STAFF RECOMMENDATION
1707 Blair Boulevard
April 10, 2017

Application: New construction—addition and outbuilding; Setback determination
District: Belmont-Hillsboro Neighborhood Conservation Zoning Overlay
Council District: 18
Map and Parcel Number: 10416009000
Applicant: Martin Wieck, Nine12 Design
Project Lead: Melissa Baldock, melissa.baldock@nashville.gov

Description of Project: Application is to construct an addition to an historic house with a mid-way parking pad and to construct a detached building at the rear with 4 attached parking bays. The historic house and addition will have three dwelling units in it, and the rear structure will have two dwelling units in it. The rear structure requires a rear setback determination. **Recommendation Summary:** Staff recommends disapproval of the project, finding that the height, scale, roof form, and orientation of the addition and rear structure do not meet Sections II.B.1.a., II.B.1.b., II.B.1.e., II.B.1.f., II.B.1.i., and II.B.2. of the Belmont-Hillsboro Neighborhood Conservation Zoning Overlay design guidelines. The Commission does not have the authority to approve the use. This recommendation is for the design of the buildings ba

1 Site Plan

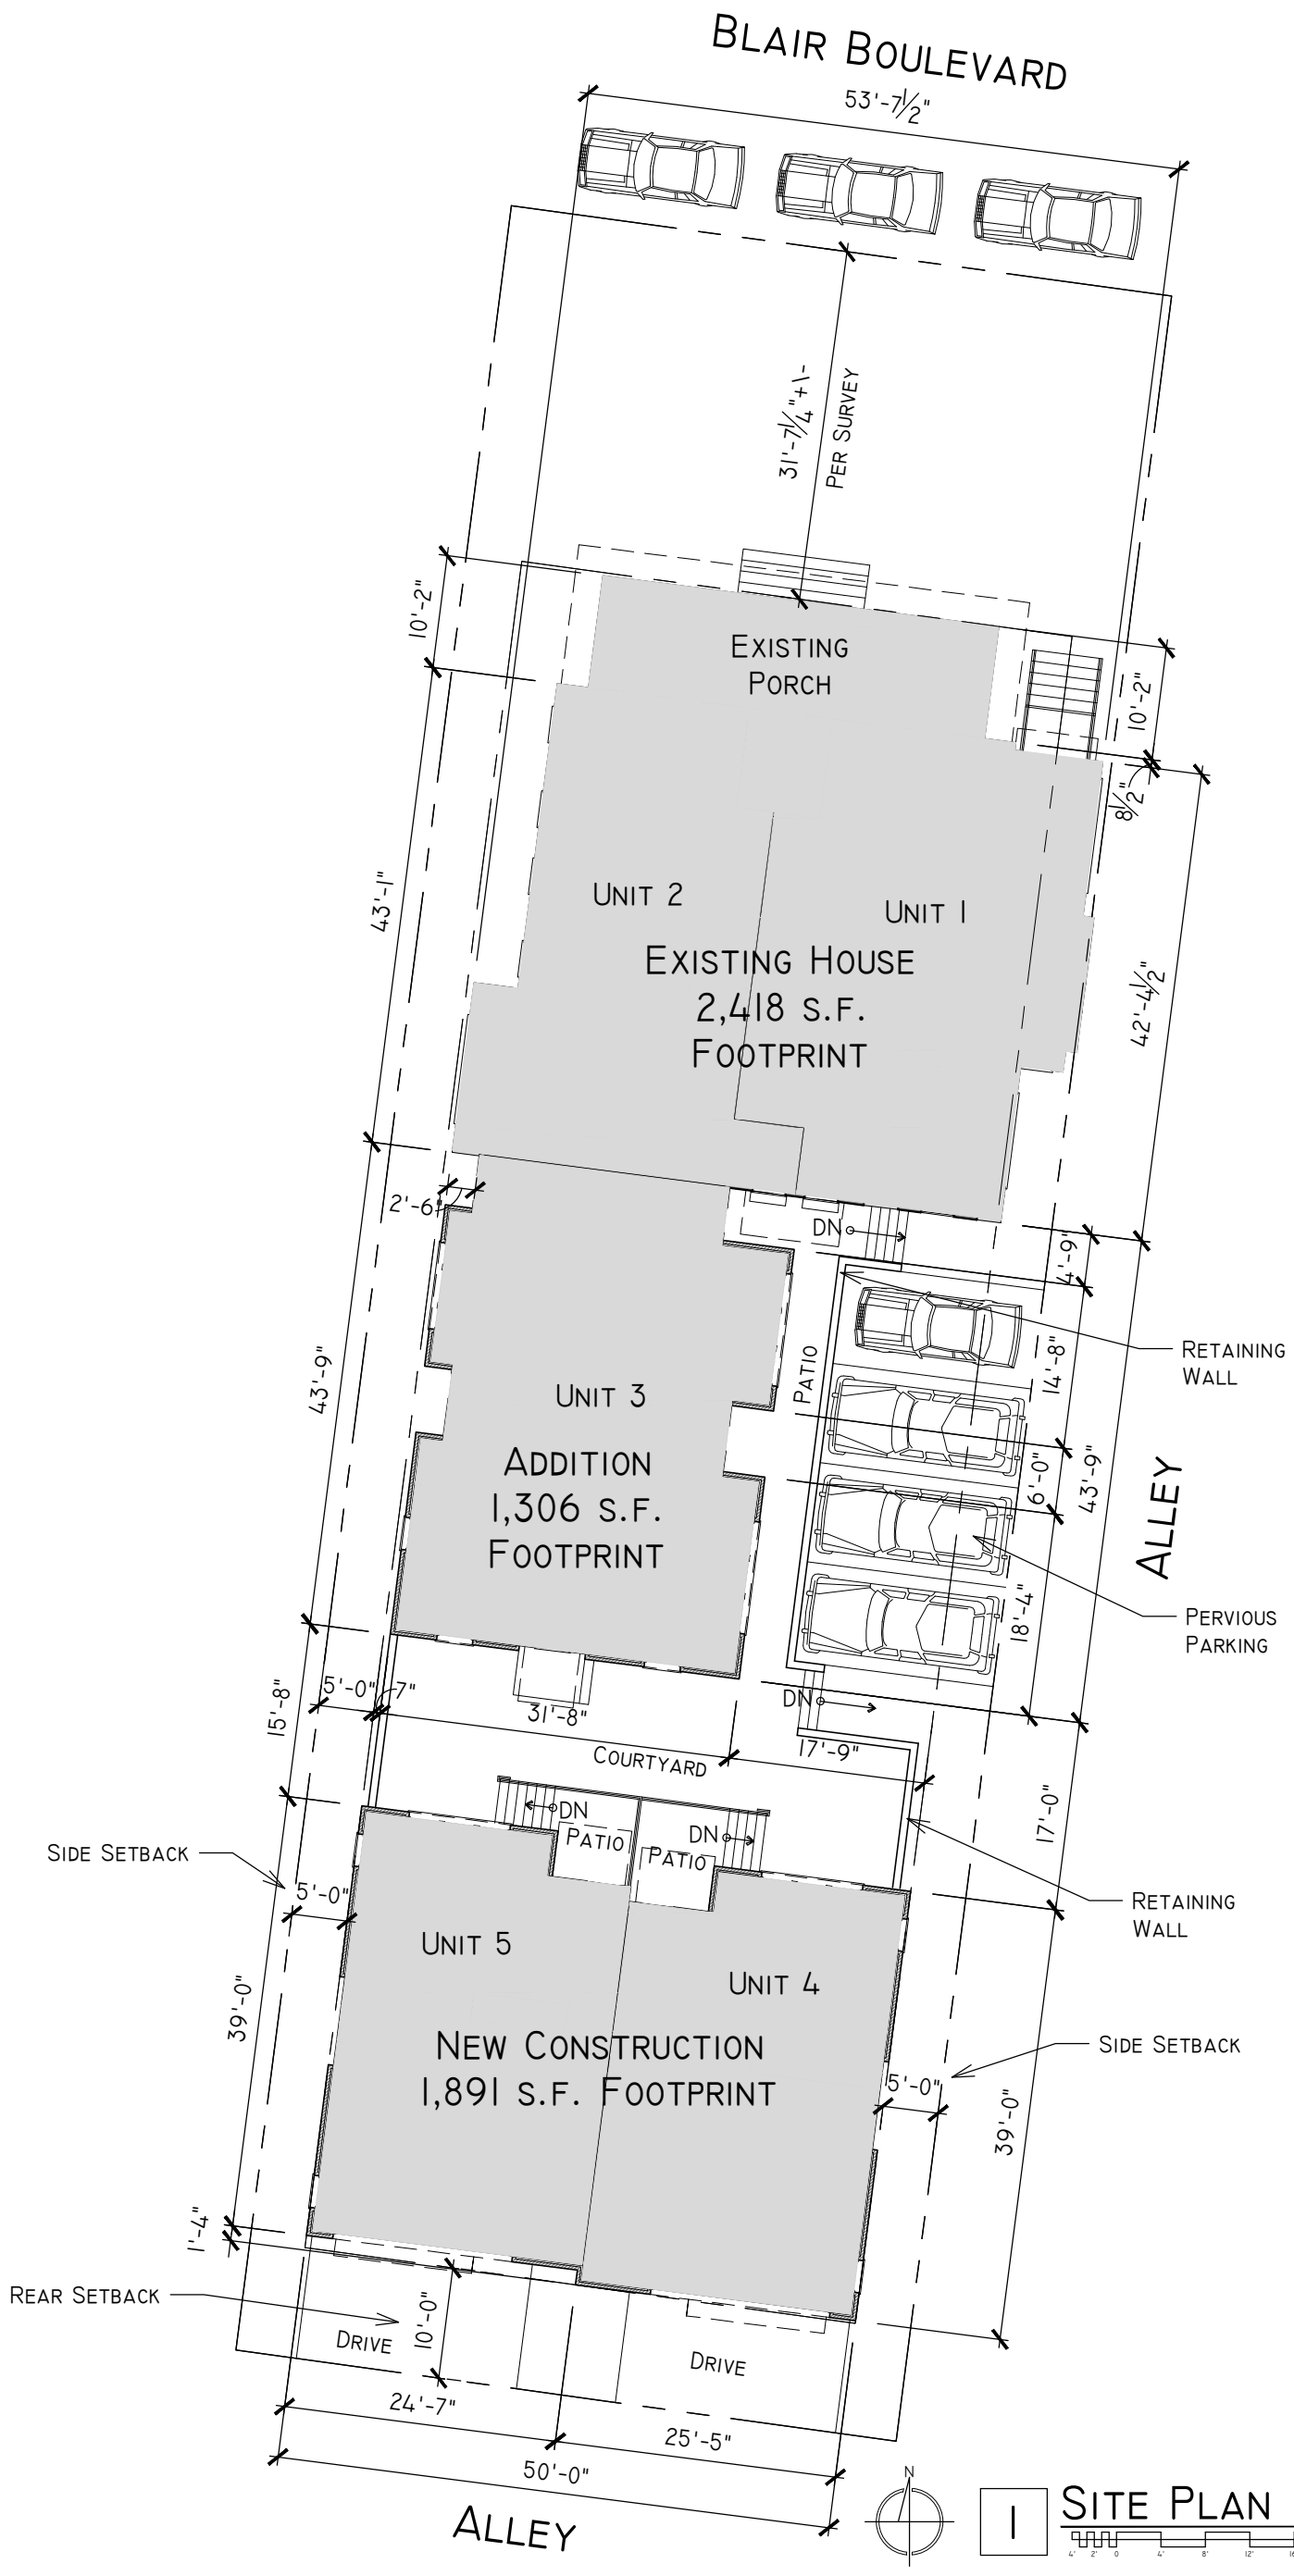
Addition Setback & Rhythm of Spacing: The proposed addition meets all base zoning setbacks. It will be five feet, seven inches (5'7") from the right side property line, approximately twenty-three feet (23') from the left side property line, and approximately sixty-six feet (66') from the rear property line. Because the addition is no wider than the historic house, the rhythm of spacing along Blair Boulevard will not be affected. Staff finds that the proposed addition meets Sections II.B.1.c. and II.B.2. of the design guidelines.

No changes to the existing pathways were indicated on the drawings. Vehicular access to the site will be via both the side and the rear alleys, which is appropriate.

Appurtenances & Utilities: Parking for four cars will be provided off of the side alley, behind the historic house. Staff finds this to be appropriate. Because of the slope of the site, a retaining wall of split face block will be built to create the parking areas as well as a courtyard and other patio areas. The location of the HVAC and other utilities was not noted. Staff recommends that the HVAC be located on the rear façade, or on a side façade beyond the midpoint of the house. With this condition, staff finds that the project's appurtenances and utilities meet the design guidelines.

The rear structure will meet the five feet (5') base zoning setbacks on the sides. Base zoning requires that all new construction be a minimum of twenty-feet (20') from the rear property line. The applicant is proposing to situate the rear structure as close as eight feet, six inches (8'6") from the rear property line. If the scale of the outbuilding is reduced, staff finds that the proposed rear setback could be appropriate, as it would allow for more room between the historic house/addition and the rear structure. A shorter rear setback would also reduce the visibility of the rear structure from the street and would reduce its impact on the historic house.

1 West Elevation

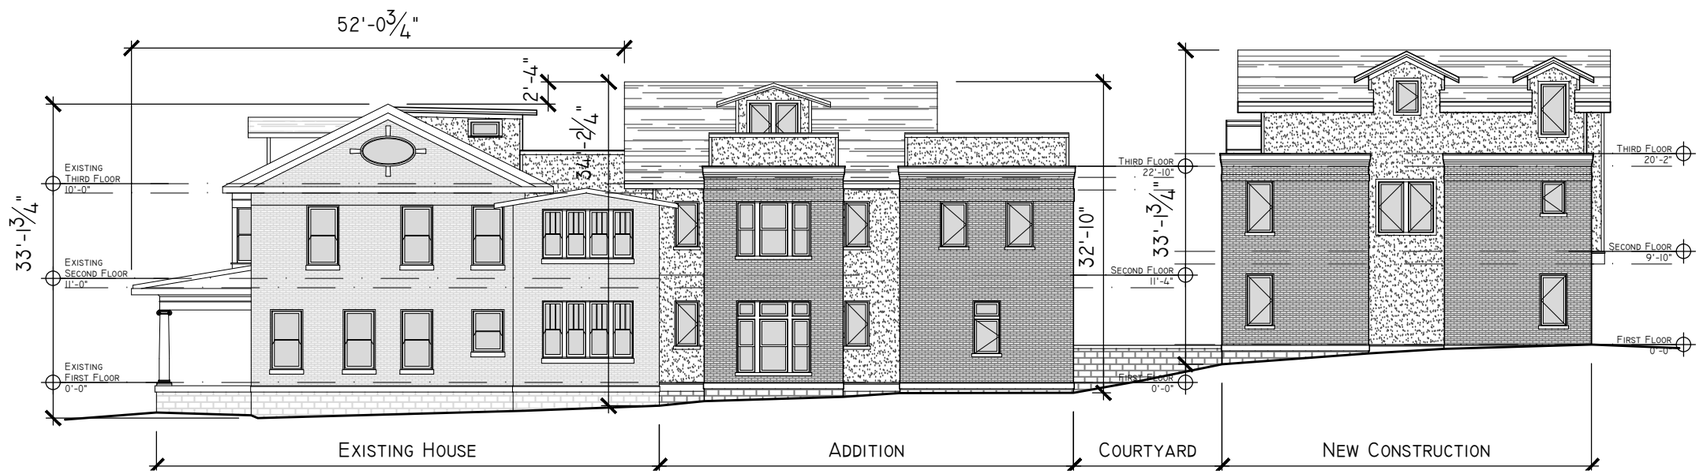
The historic house is two-and-a-half stories with an eave height of approximately twenty-three feet (23') and a ridge height of thirty-three feet (33'). The addition will also be approximately two-and-a-half stories in height; but will be two feet, four inches (2'4") taller than the historic house. The design guidelines state:

The design guidelines only permit additions to be taller than the historic house when the historic house is one story in height. It is not appropriate for an addition behind a two-and-a-half story house to be taller than the historic house, particularly when there are no other severe lot constraints. The wall dormers on the addition, which meet the ridge of the roof, and the balconies above the second story level further serve to accentuate the height and scale of the addition. Staff finds that the addition's height and scale do not meet Sections II.B.1.a., II.B.1.b., and II.B.2.a. of the design guidelines.

Addition Design: The addition's insets, change in materials, and separate roof form distinguish it from the historic structure. However, its height, scale, wall dormer, and balconies above the second story are not compatible to the historic structure. Staff therefore finds that the addition's design does not meet Sections II.B.2.a. and II.B.2.f of the design guidelines.

Addition Roof form: The addition includes a flat-roofed dormer that ties into the back of the historic house at a point six inches (6") below the ridge. The dormer is inset two feet (2') from the side walls of the house, which is appropriate. The taller portion of the roof will have an 8/12 front-facing gable form. The design guidelines state that taller portions of the addition should be clipped, hipped or side gable form. Even with an appropriate roof form, the addition is taller than the historic house; therefore, staff therefore finds that this roof form does not meet the design guidelines.

The brick part of the addition will have a flat roof form. Staff finds that a flat roof could be appropriate if the top of the roof is no taller than the historic house's eave height. In this case, the top of the flat roof is a foot (1') taller than the top of the historic house's eave. Above the flat roof will be a wall dormer that contains access to a balcony above the second story. The balcony includes a wall/barrier that is three feet, six inches (3'6") above the flat roof. Because the flat roofs are taller than the historic house's eave and because they are paired with wall dormers and three foot, six inch (3'6") balcony barriers, staff finds that the roof form is not appropriate.

The left façade contains a hanging metal balcony at the second story level. Although atypical, staff finds this to be appropriate because it will be located eighteen feet (18') inset from the side wall of the historic house.

Recommendation Summary: Staff recommends disapproval of the project, finding that the height, scale, roof form, and orientation of the addition and rear structure do not meet Sections II.B.1.a., II.B.1.b., II.B.1.e., II.B.1.f., II.B.1.i., and II.B.2. of the Belmont-Hillsboro Neighborhood Conservation Zoning Overlay design guidelines.

2 Units 4&5 East/West Elevation

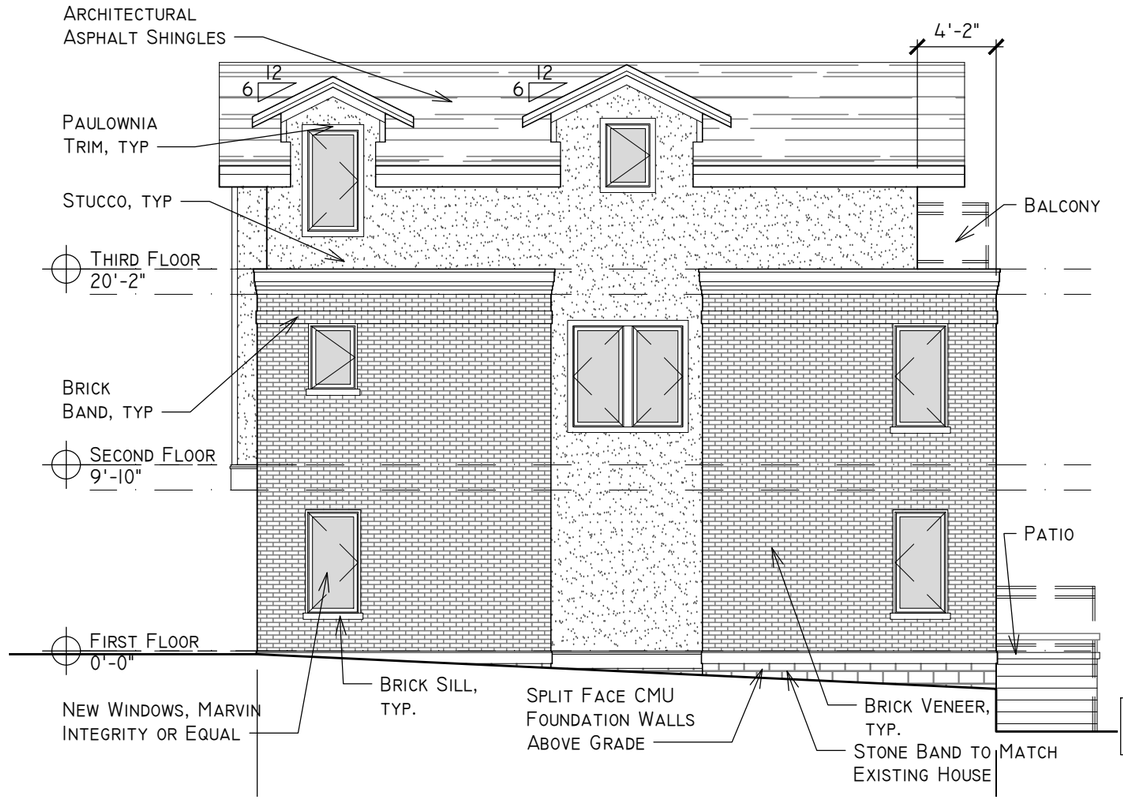
The proposed rear building will be three stories and will have a maximum height of thirty-three feet (33'). This is the same height as the front of the historic house, but because the site slopes up towards the back, the rear building will appear taller than the historic house. Staff finds that the three story scale of the rear building is not appropriate because it is larger than the historic house, which is two and a half stories. Any rear structure should have a height lower than the historic building and be a maximum of two and a half stories.

The rear building will have a footprint of one thousand, eight hundred and ninety-one square feet (1,891 sq. ft.). For a traditional outbuilding, the design guidelines limit the footprints of outbuildings to one thousand square feet (1,000 sq. ft.) on lots larger than ten thousand square feet (10,000 sq. ft.) like this one. Because the lot is zoned RM 20, staff finds that it could be appropriate for an outbuilding to have a footprint larger than one thousand square feet (1,000 sq. ft.). However, staff finds the proposed footprint and overall scale to be too large for the site and the historic context. The footprint does not allow for the minimum space of twenty feet (20') between the back of the primary structure and the rear structure, as is typically required. The footprint, combined with the three story form and the wall dormers, results in a rear structure that is too large for the site and is not sufficiently subordinate to the historic structure. Although zoned for five units, the historic context is primarily single-family and two-family houses. The scale of the rear structure is not appropriate to the historic context.

The rear structure will contain parking on the ground floor facing the alley. The attached parking, as well as the proposed materials and fenestration pattern, meet the design guidelines.

Because of the outbuilding's height, three story form, and large footprint, staff finds that the rear building does not meet Sections II.B.1.a., II.B.1.b., and II.B.1.i. of the design guidelines.
